Members' Library Service Request Form

Date of Document	18/10/24
Originator	Ian Chalmers
Originator's Ref (if any)	
Document Title	Musselburgh Flood Protection Scheme MLS report - Appendix
	A.6

(0146) MUSSELBURGH FLOOD PROTECTION SCHEME 2024

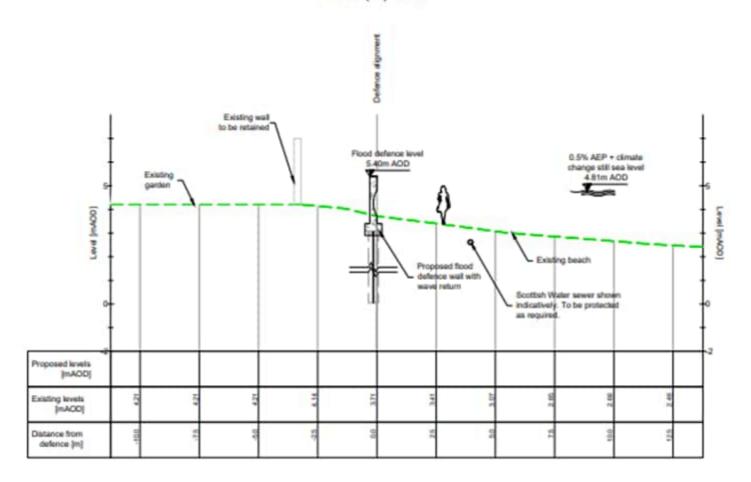
I am a resident just west of the Edinburgh/Musselburgh boundary and as a tax payer I am writing to object on technical grounds to one aspect of the Musselburgh Flood Protection Scheme.

The new flood defence wall from 29 to 35 Edinburgh Road (see Section A below) should be constructed to the same specification as the new flood defence wall from Murdoch Green to the Back Sands Car Park (see Section B below). I say this because the proposed wall along the former section has no supporting foot, but the wall along the latter section does.

Section B. New Flood Defence Wall from Murdoch Greeen to Back Sands Car Park.

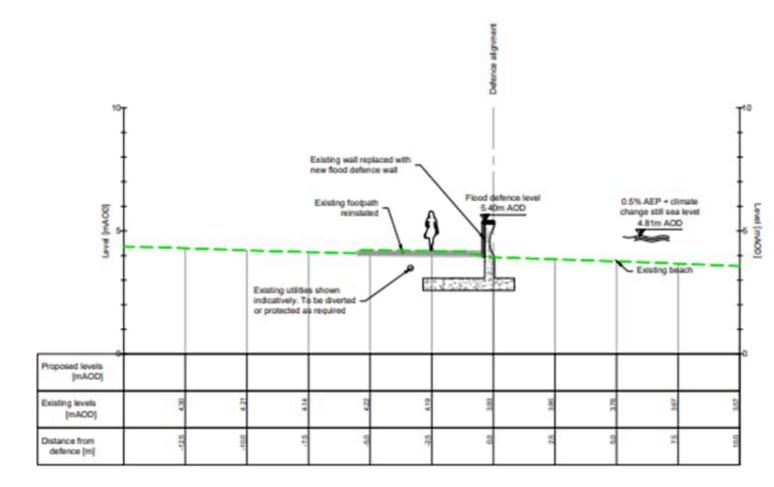
If you disagree with my objection please provide arguments supported with detailed evidence and references thereto, so that I can examine your reasons for rejecting my objection. Your reasons for rejection will not be acceptable if they are of a general nature. This will only mean I reply to you asking for a more detailed response.
